APPROVED PLAN OF DEVELOPMENT

Amendment		PROJECT: PROPOSED RENOVATIONS TO EXISTING HINDU EDUCATIONAL CENTRE 4915-4923 MT LYNDESVY HWAY, STH MACLEAN, QLD		DRAWING TITLE: TEMPLE RENOVATION PROPOSED SITE PLAN	
A	25.06.09 Issued for client review				
D	12.07.11 Building 1 - Dimension and concrete walkway added				
E	19.03.12 Landscape and traffic plan added, second gate deleted and size/location of 2, 3, 16, 7a & 14 amended or shown				
		DESIGNED BY: DP		DRAWING SCALE:	
		DRAWN BY: DP		DRAWING NUMBER:	
		DATE: AUG 2010		ISSUE:	
		PROJECT No. 090520		1:1000 @ A3	
				BA02	
				E

RELEVANT ENTITY RESPONSE NOTICE – NO OBJECTION

Proposed Development: Request to Change Development Approval - Material Change of Use – Public Worship (Extension)
Real Property Description: Lot 423 WD3792
Street Address: 4915-4923 Mount Lindesay Highway, South Maclean QLD 4280
Assessment Manager ref.: MCUI/29/2009
Local Government Area: Logan City Council

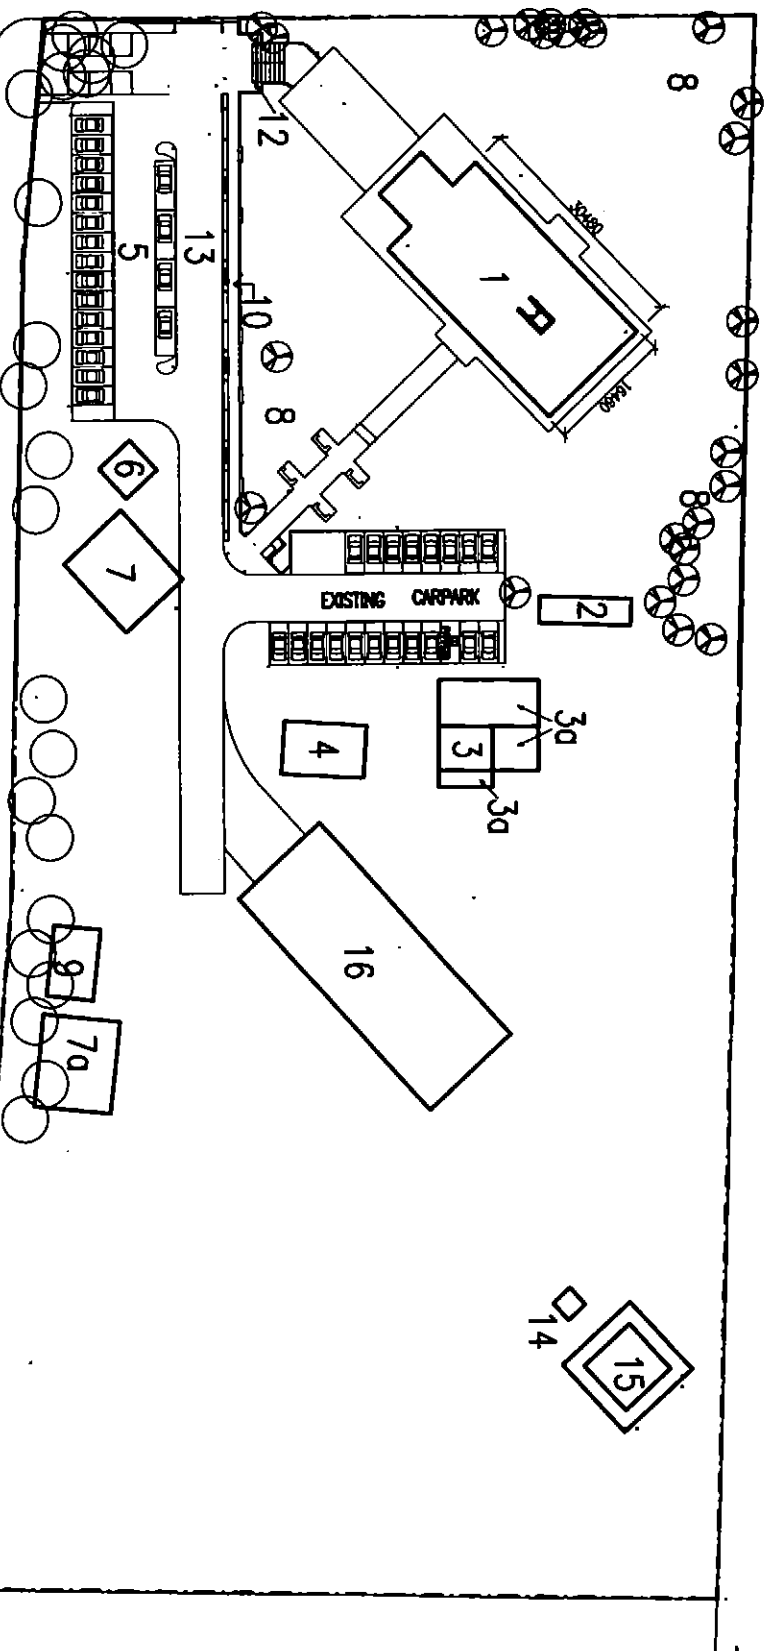
- Relocation of proposed buildings as well as the addition of new structures including a temporary temple structure;
- Deletion of the driveway access to Casuarina Road.
- Amendments to the layout of walkways and parking layout{

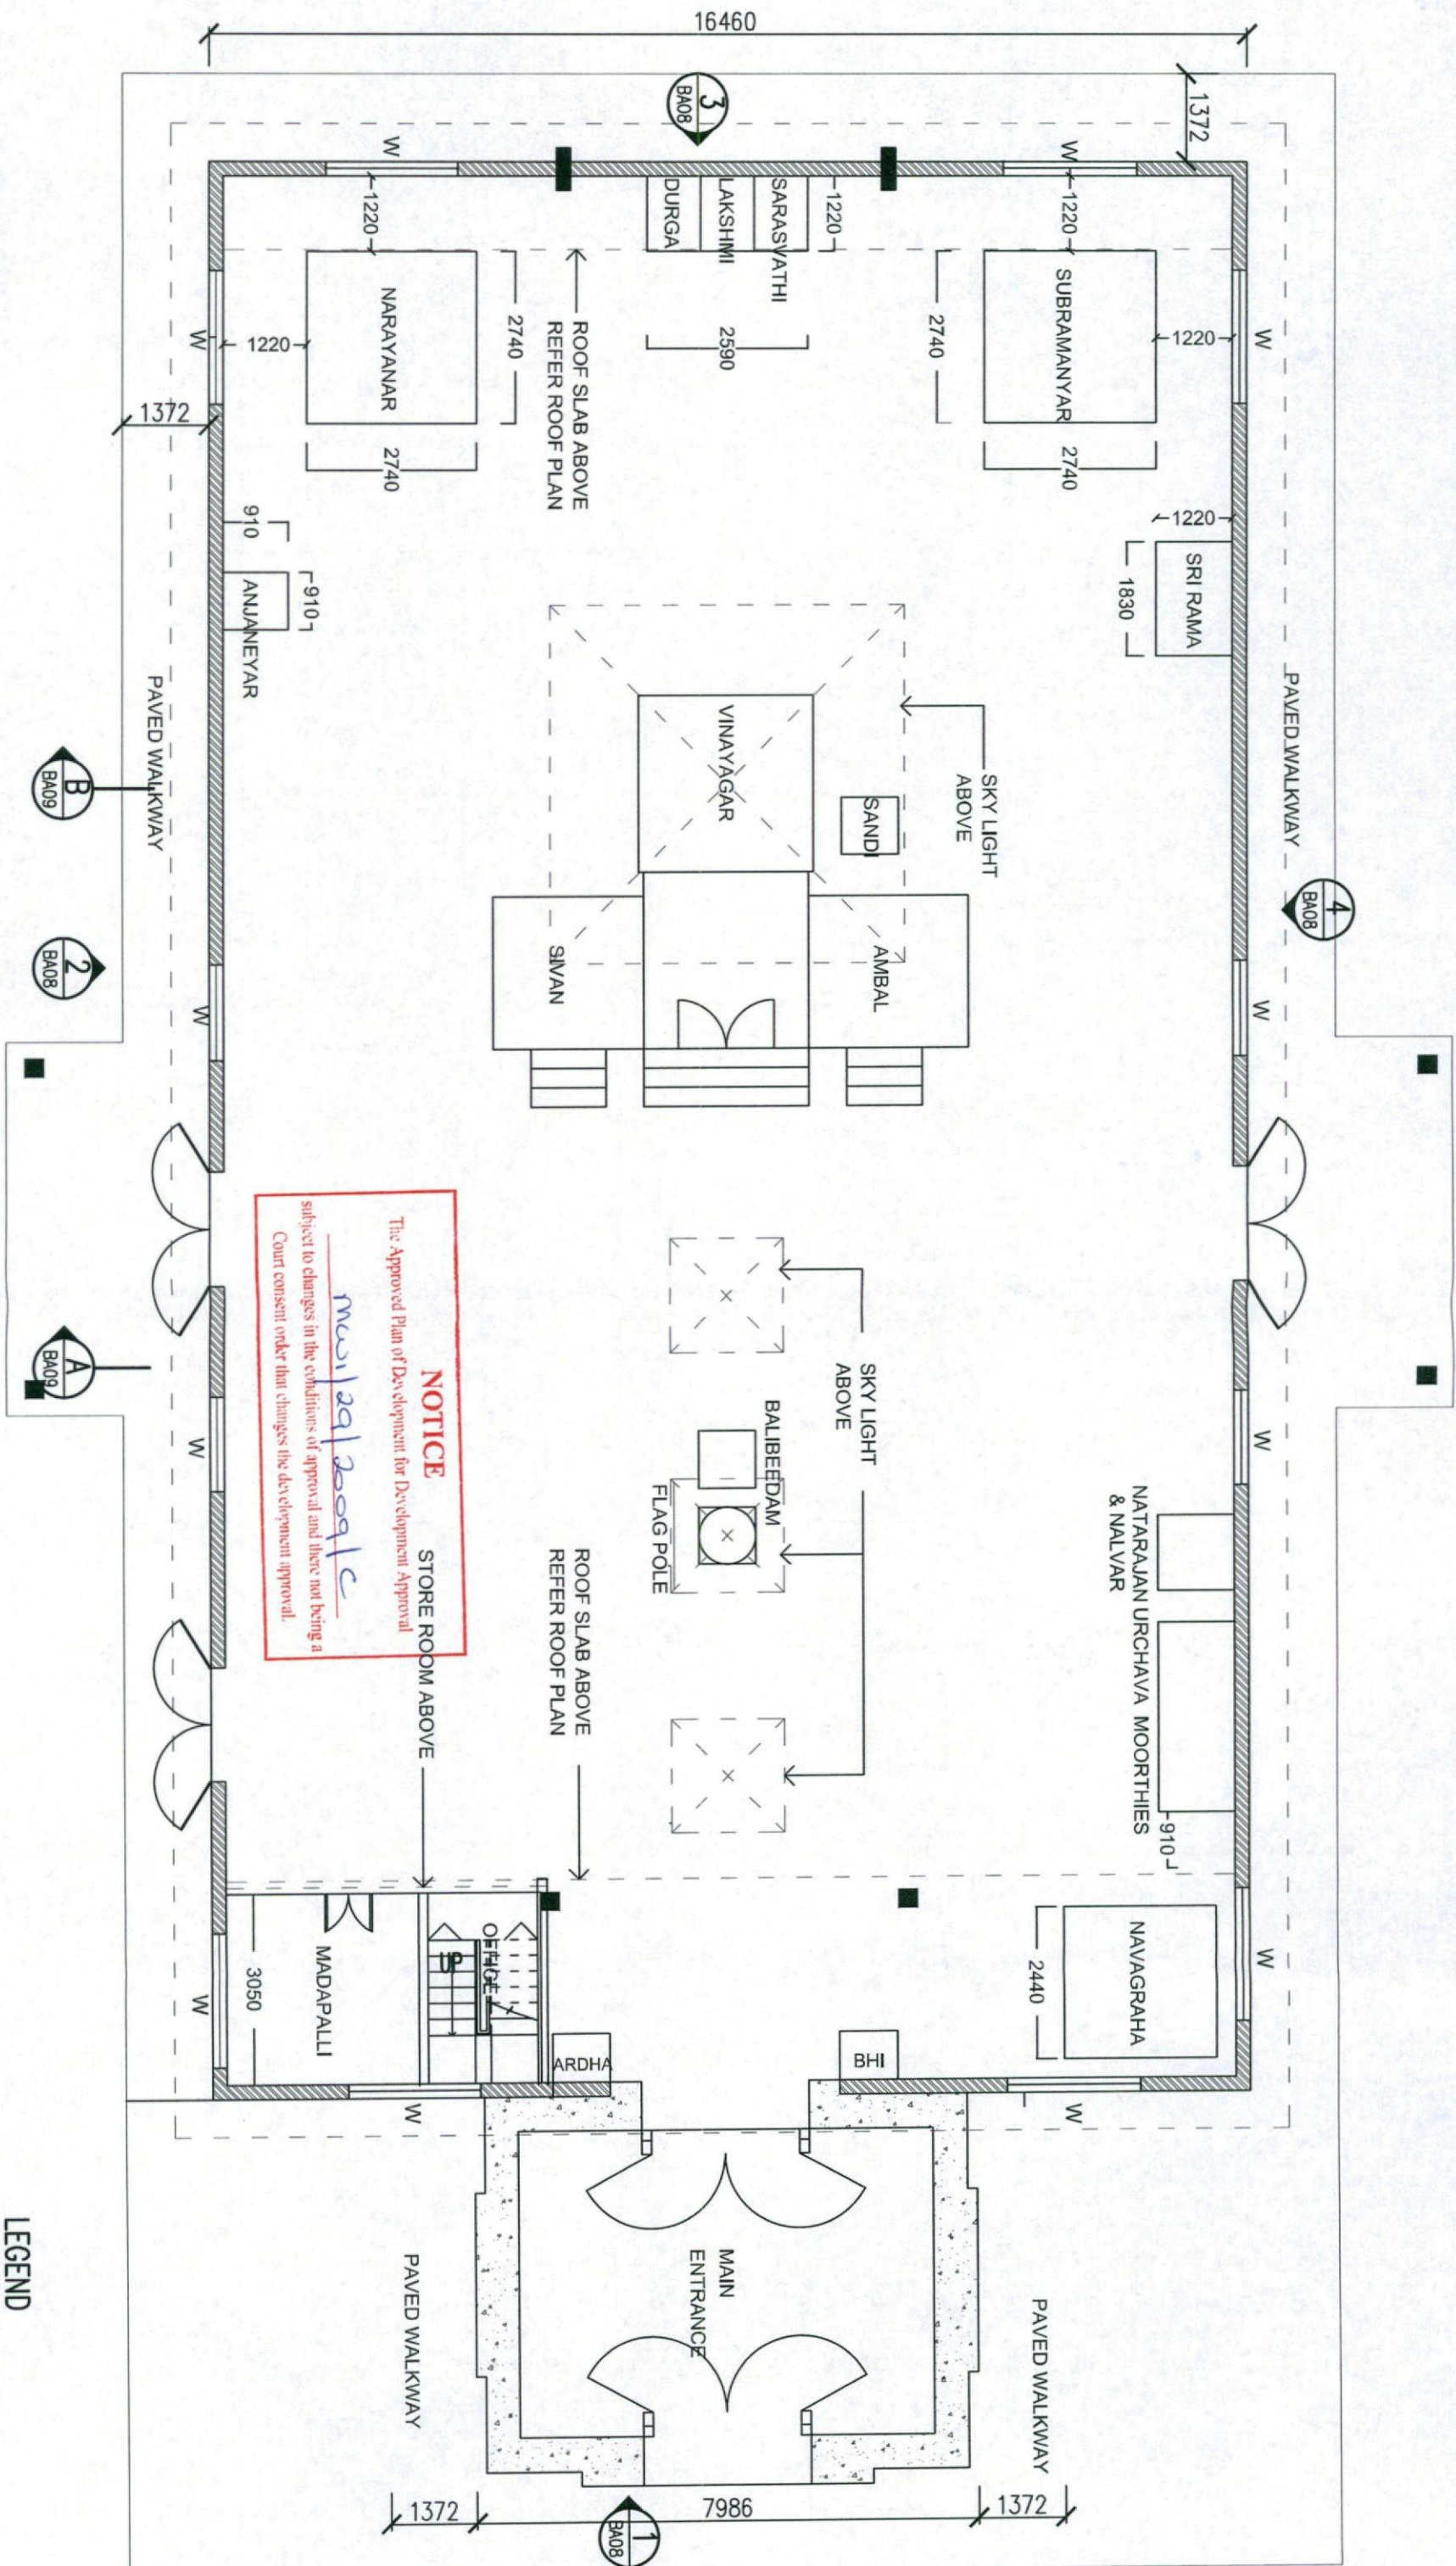
Amendment	PROJECT	DRAWING TITLE:
F 19.08.10	PROPOSED RENOVATIONS TO EXISTING HINDU EDUCATIONAL CENTRE 4915-4923 MT LYONS WAY, SM MACLEAN, QLD	TEMPLE RENOVATION ROOF PLAN - PROPOSED
G 19.03.12	SKYLIGHT BEHIND THE DOME DELETED	
	DESIGNED BY: DP	DRAWN BY: DP
	DATE: AUG 2010	PROJECT No. 090520
		DRAWING SCALE: 1:1000 @ A3
		DRAWING NUMBER: BA07
		ISSUE: G

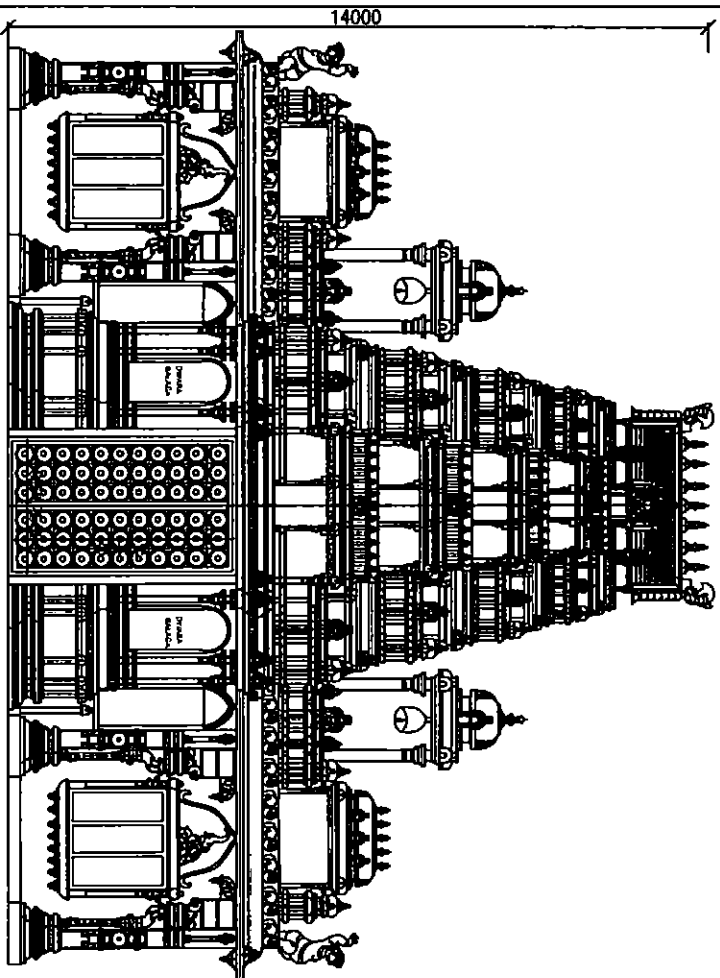
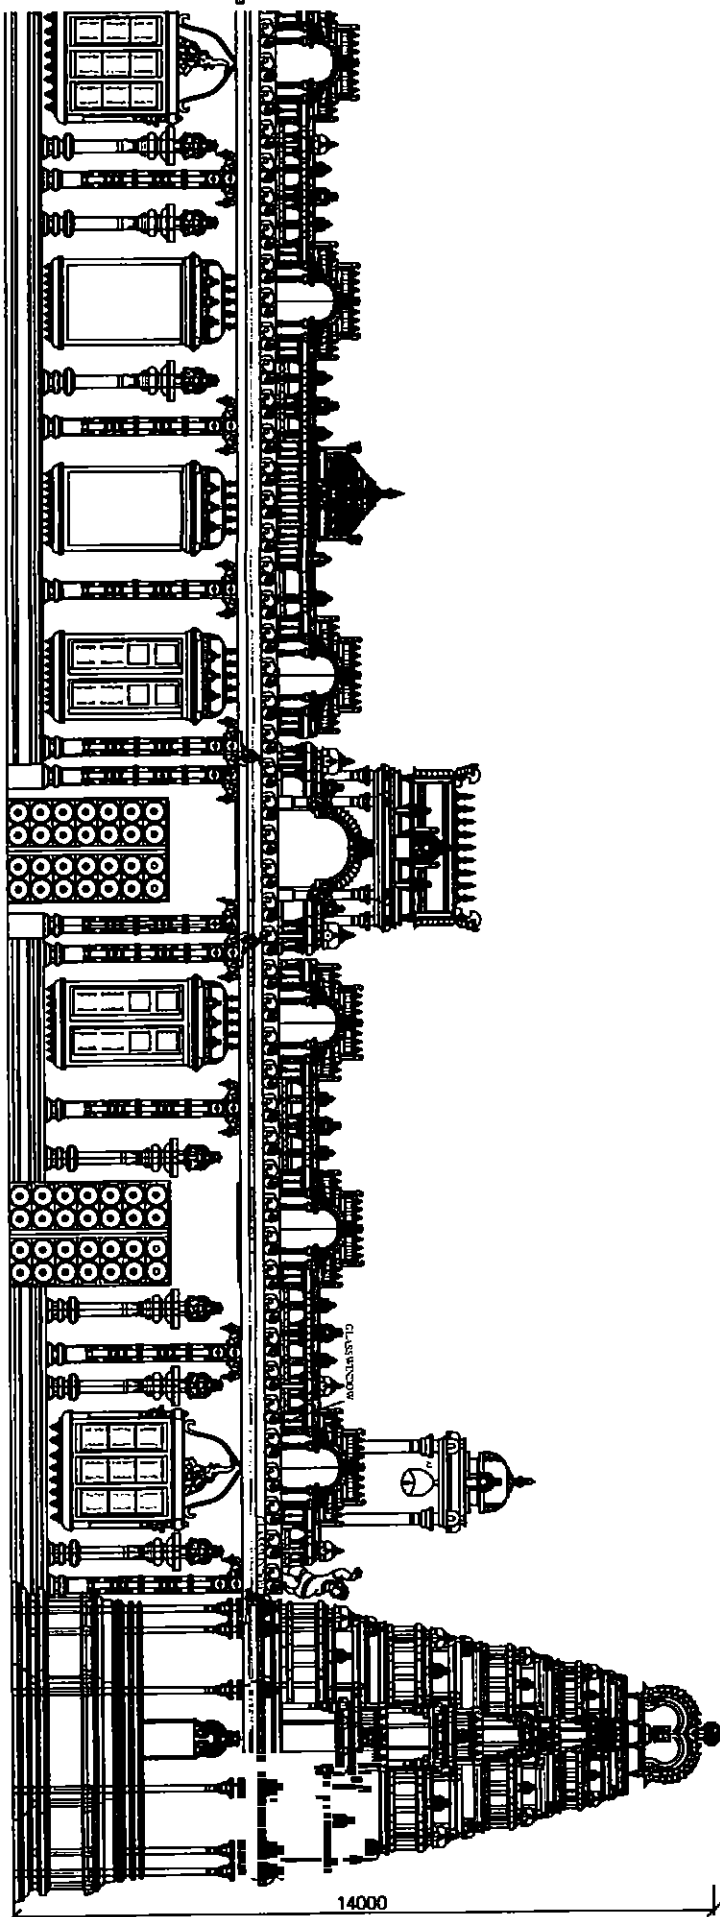
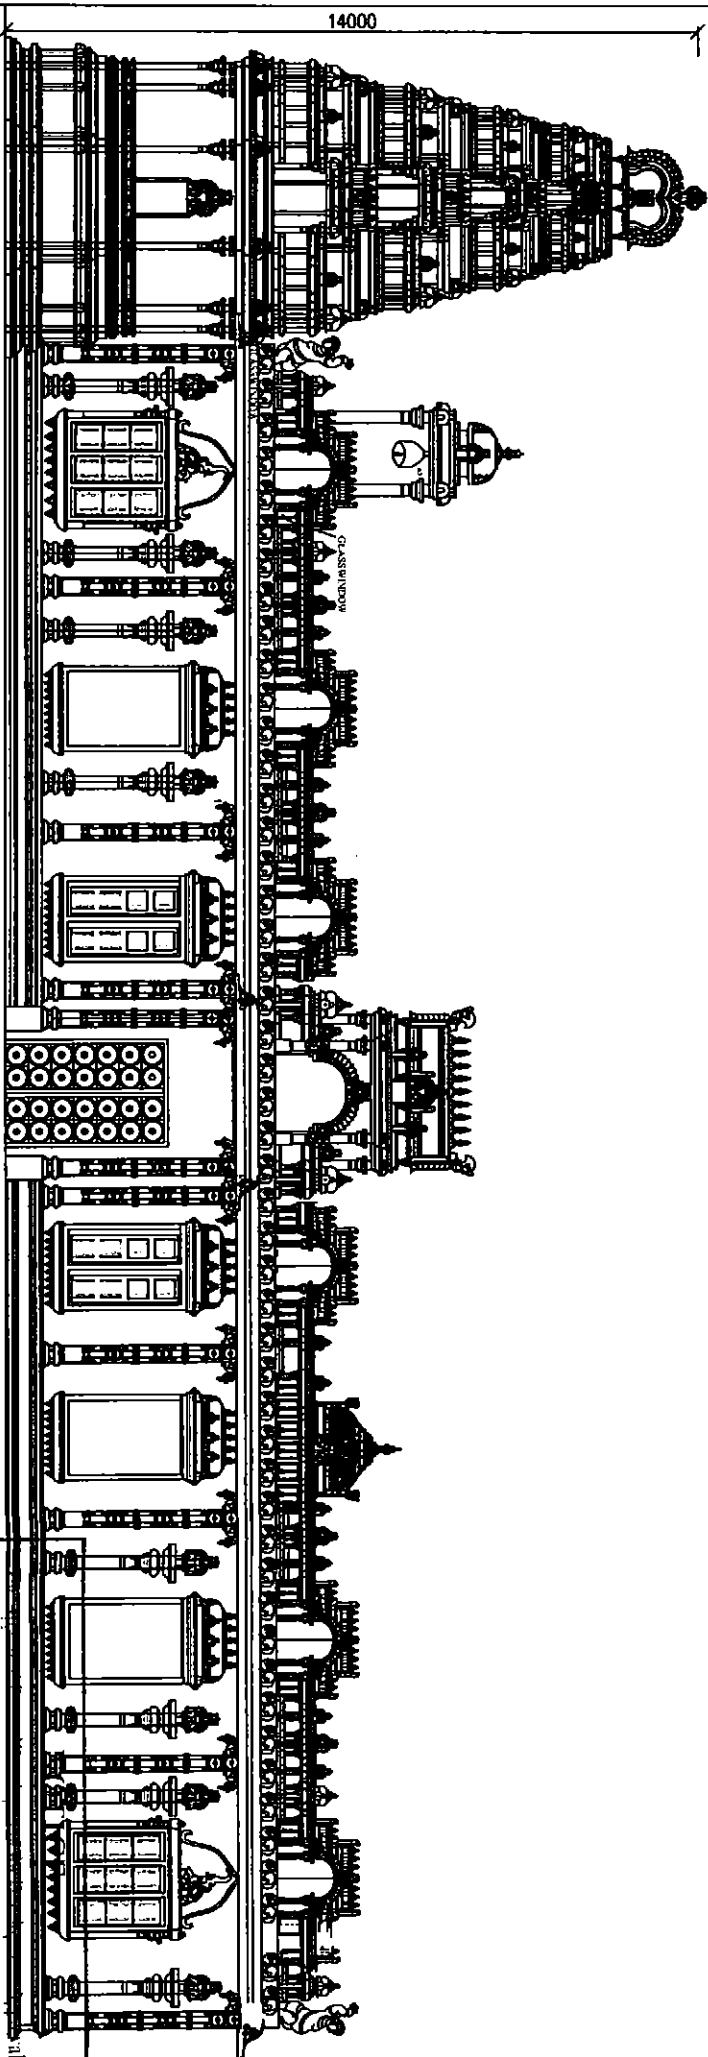
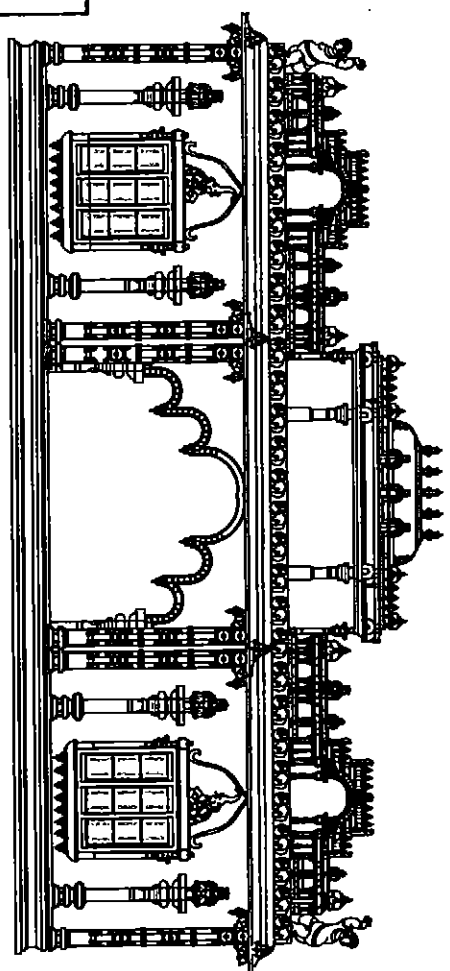
Amendment		PROJECT: PROPOSED RENOVATIONS TO EXISTING		DRAWING TITLE:	
D	06.08.10	ISSUED FOR CLIENT REVIEW	HINDU EDUCATIONAL CENTRE	TEMPLE RENOVATION	
E	12.07.10	ELEVATIONS REVISED TO SUIT HINDU TEMPLE ARCHITECTURE	4915-4923 MT LYNDESAY HWY, STH MACLEAN, QLD	ELEVATIONS - PROPOSED	
F	19.03.12	ELEVATIONS REVISED TO SUIT HINDU TEMPLE ARCHITECTURE	DESIGNED BY: DP	DRAWING SCALE:	
			DRAWN BY: DP	DRAWING NUMBER:	
			DATE:	1:150 @ A3	
			PROJECT NO.	BA08	
				ISSUE:	
				F

SRI SELVA VINAYAKAR TEMPLE, SOUTH MACLEAN, QLD			
TITLE: ANATHANA MADAM & KITCHEN – GENERAL ARRANGEMENT			
DRAWN: SRI	DATE: March 2012	DWG NO: BA12	
APPROVED: SRI	SCALE: AS SHOWN	REVISION: A

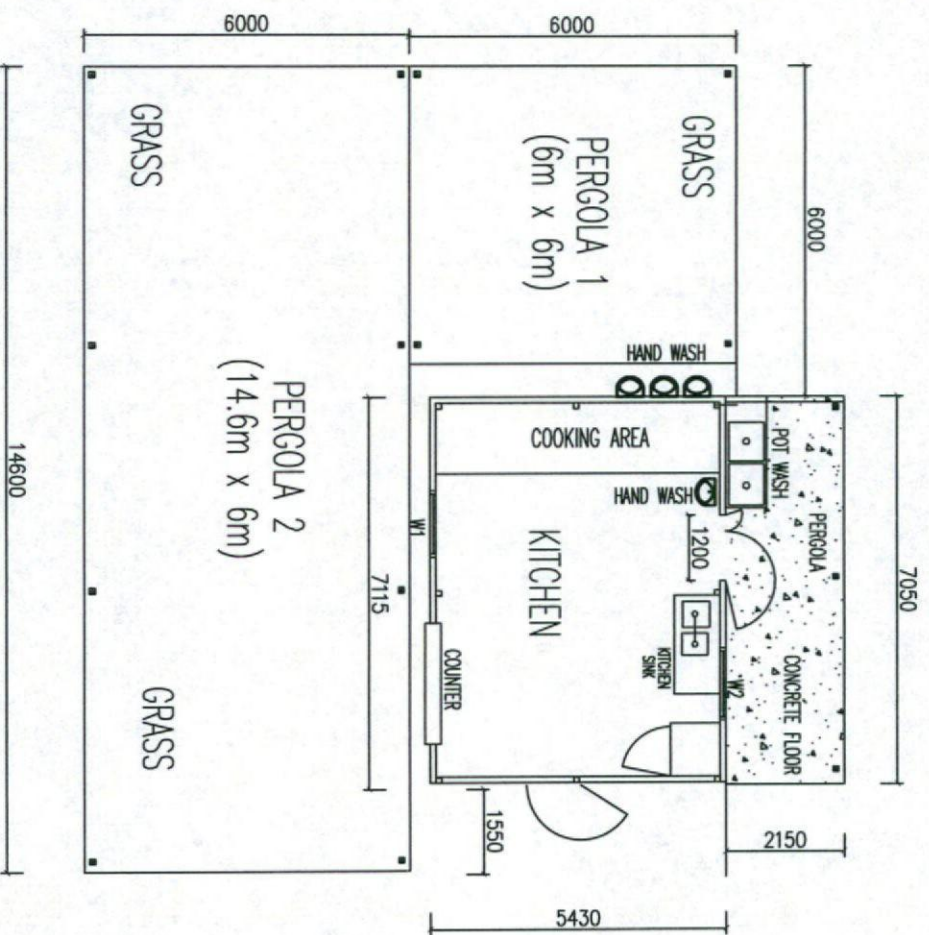
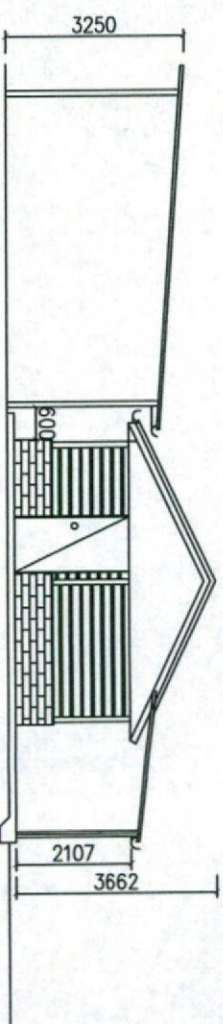
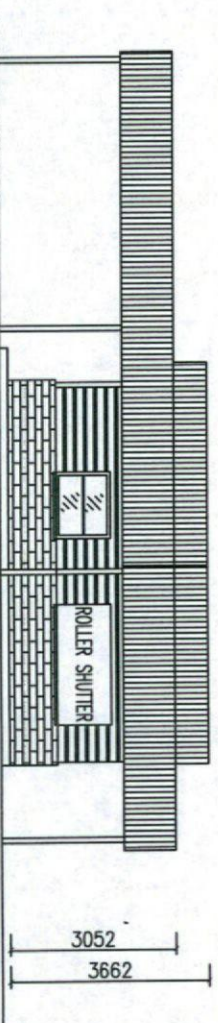
SRI	PROJECT NO:	SHEET NO:
				SRI	HAS-012012	CA 1 of 1
A	19/03/12	Pergolas added for DA approval				
REV	DATE	AMENDMENT				
				BY		
NOTE						
1. Do not scale from drawing						
2. Verify all dimensions on site						
3. All discrepancies are to be highlighted to the client						
4. This drawing is Copyright

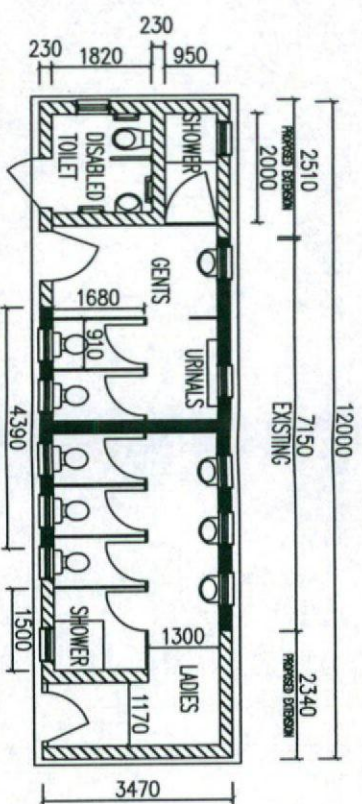
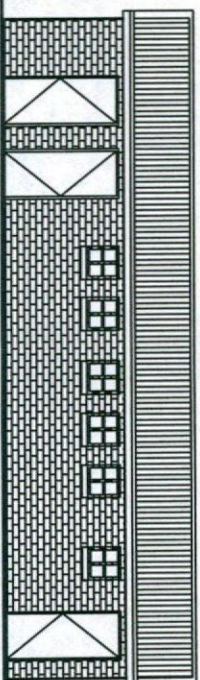
PROJECT NO:	HAS-012012	SHEET NO:	AB 1 of 1
			NOTE 1. Do not scale from drawing 2. Verify all dimensions on site 3. All discrepancies are to be highlighted to the client 4. This drawing is Copyright			
A	19/03/12	SHOWERS AND PWD ADDED FOR DA				
NO	DATE	AMENDMENT	BY			
SRI SELVA VINAYAKAR TEMPLE, SOUTH MACLEAN, QLD						
TITLE: PROPOSED AMENITIES BUILDING						
DRAWN: SRI		DATE: MARCH 2012		DWG NO: BA13		
APPROVED: SRI		SCALE: AS SHOWN		REVISION: A
